Seagate Technology
10323 West Reno (West Dock)
Oklahoma City, OK 73127-9705
P.O. Box 12313
Oklahoma City, OK 73157-2313

4/24/2000
John Lohmeyer
T10 Chairman

Subject: Proposal for Enhanced signalling to be included in SPI-4

Figure 42 - Illustration of the driver precompensation technique.

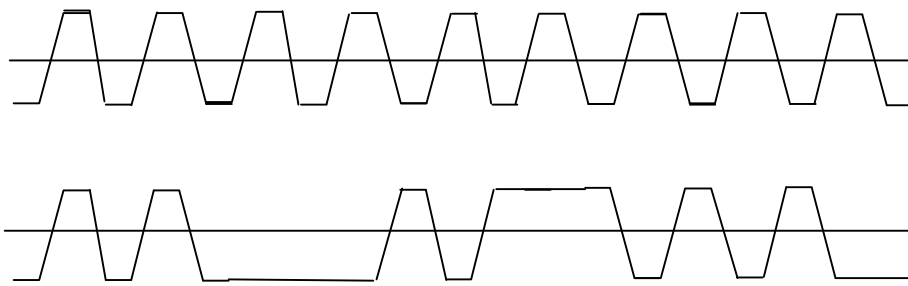
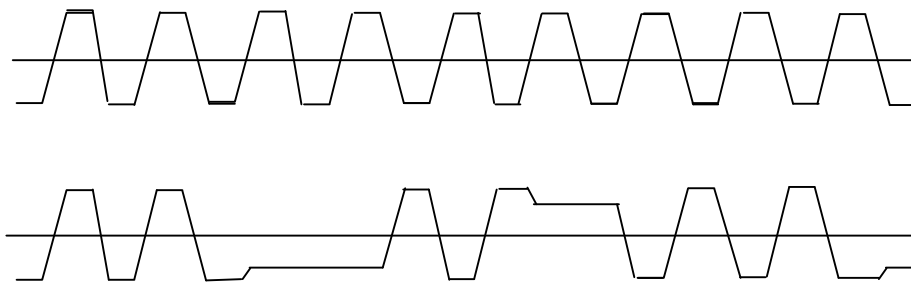
During data transfer phases, if the transfer mode is one with the PPR FRC SM (free running clock with skew management) bit set to one, the driver source current shall comply with precompensation requirements in Table (New 1). Nominal driver current is sourced to or from the SCSI Data bus line for the first data transfer time after a change in the data bus line state from asserted to negated or from negated to asserted. After a data transfer time from the last data bus line state change the current sourced to or from the SCSI Data bus line shall be cutback (reduced) (see A.2.1). The rules for precompensation shall apply to REQ, ACK, P1, P CRCA as well as DB(15-0).

Figure N.1 illustrates the transmitter drive strength technique.

Figure 45 - LVD timing measurement points for DT with FRC SM = 1 data transfers

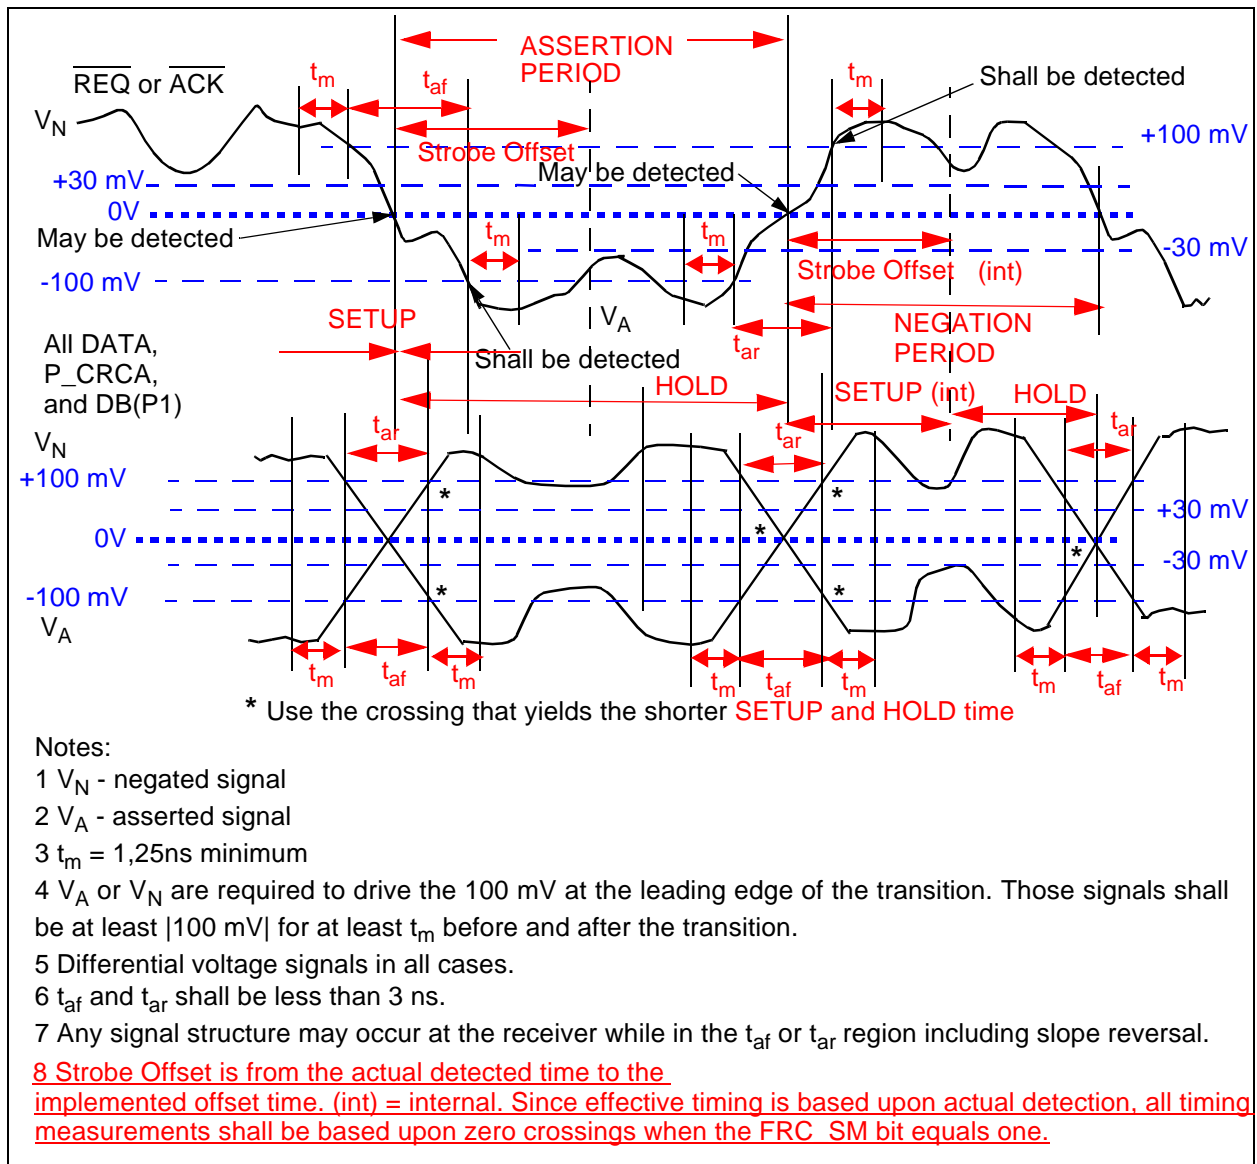
If the FRC_SM bit equals one, the timing shall be measured relative to the zero crossing of the differential signal.

Figure 50 - P1 Offset Control (Data Pacing)

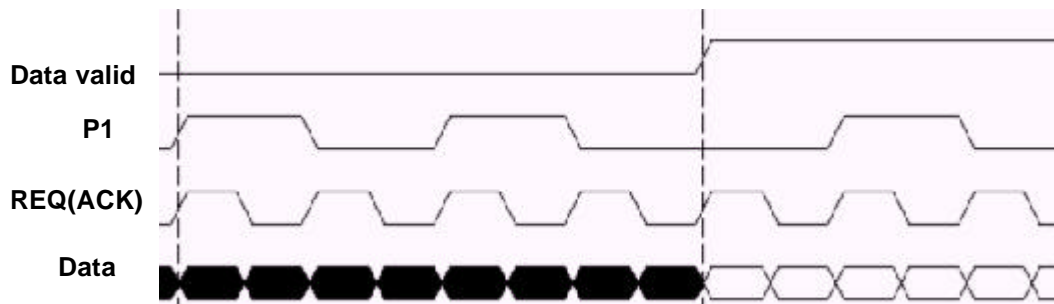
At the end of the training pattern or near the start of a data phase without a training pattern, a valid data state may begin. The sending device shall indicate the valid data state by reversing the phase of the P1 signal; (i.e., by withholding the next transition of P1 during the first two transfer periods of valid data). Beginning with the third valid data word, P1 shall be toggled every two transfer periods during valid data. The minimum duration of the data valid state is two transfer periods, and the data valid state shall last an even number of transfer periods.

Figure (new) illustrates an initial clock start-up period and start of valid data for a data phase.

If the sending device pauses the sending of data, it shall again reverse the phase of P1 by withholding P1 transitions for the first two transfer periods that do not have valid data. Beginning with the third transfer period without valid data, P1 shall be toggled every two transfer periods until valid data is sent. The data invalid state shall have at least one transition of P1 before changing states. The minimum data invalid time is four data transfer periods. This ensures a maximum run length of three cycles for P1. The data invalid state shall last an even number of transfer periods.

Figure 51 - Data In Training Pattern

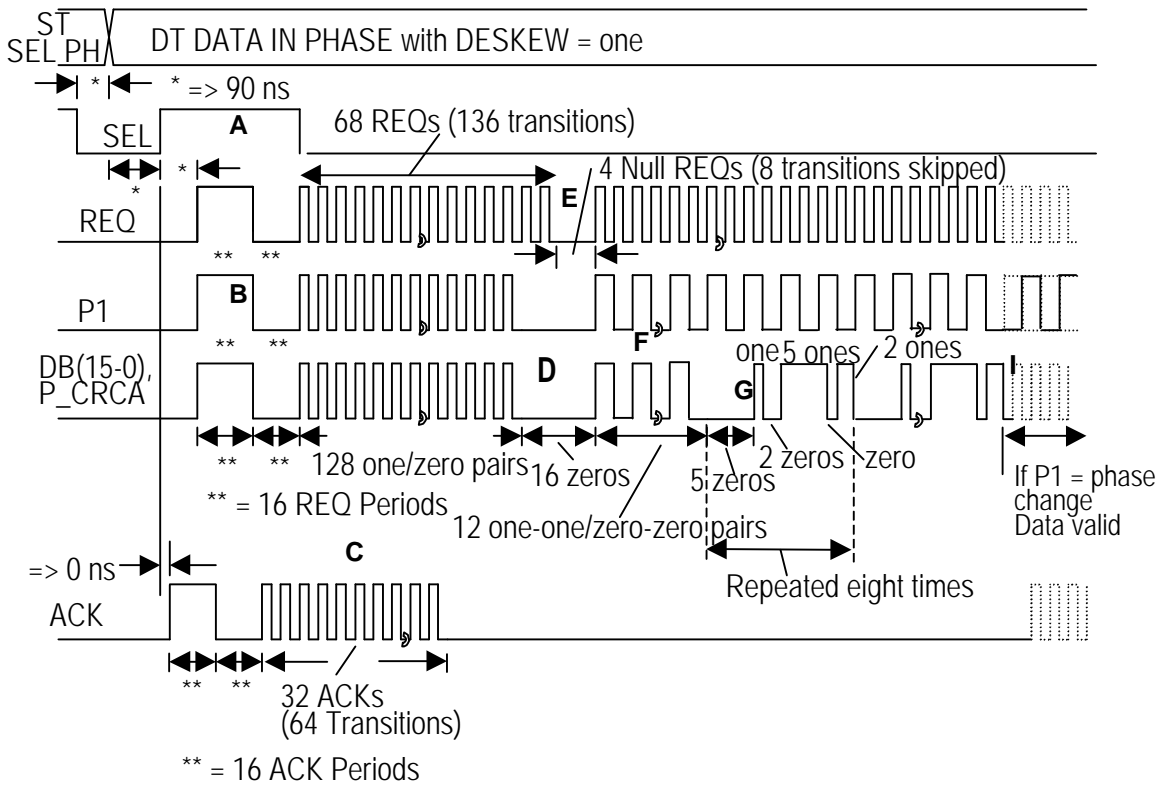
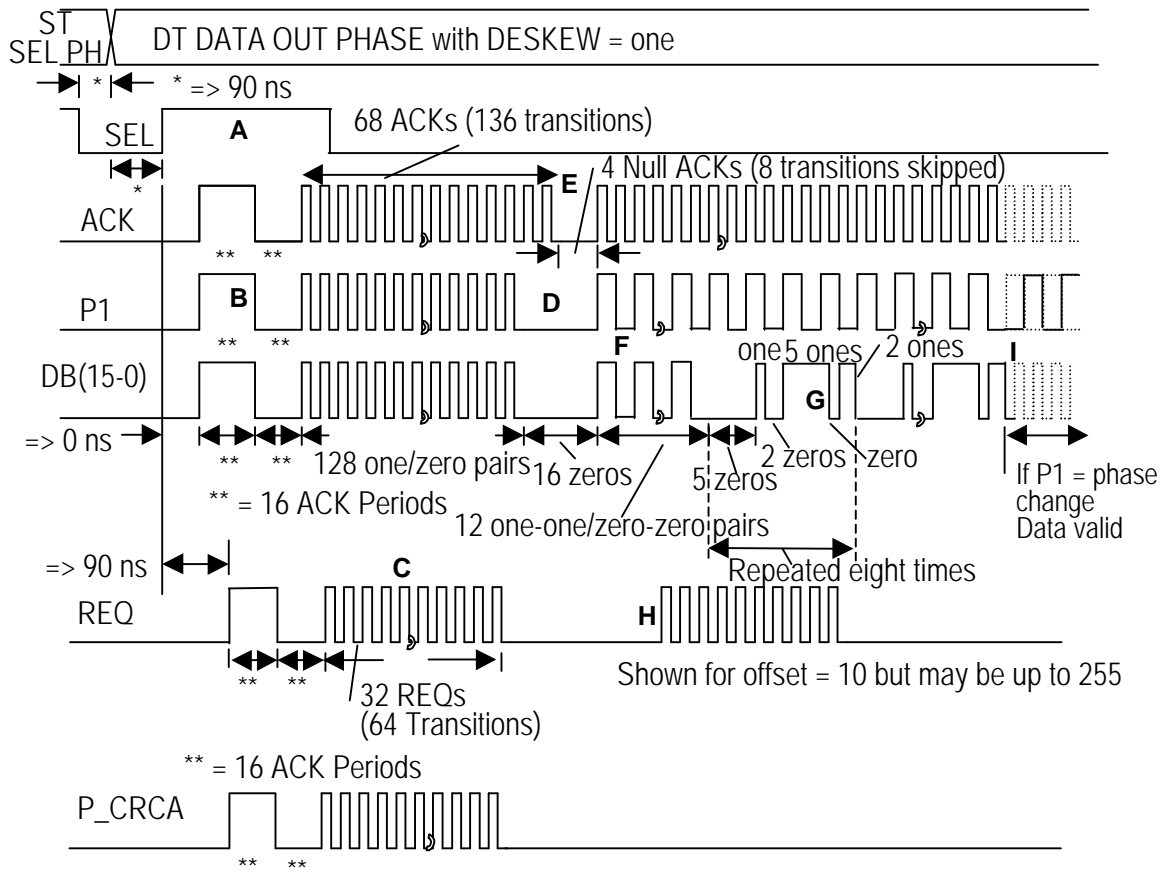
The training pattern shall be transferred at the start of the first data phase for each data transfer direction of a connection when the FRC SM bit equals one. The training pattern shall not be transferred after the start of the first data phase for each data transfer direction of a connection and shall not be transferred at all when the FRC SM bit equals zero. The training pattern for Data In shall conform to Figure TBD. The training pattern for Data Out shall conform to Figure TBD. The receiving SCSI device shall use some or all elements of the training pattern to achieve deskewing. The transmitting device shall not make an intentional shift in relative timing between the databus and the ACK(REQ) signal subsequent to the training pattern during the DT data phase. The requirement to not intentionally change relative timing does not include the effects of ISI, noise, or jitter and may be overridden by domain validation/margining requirements.
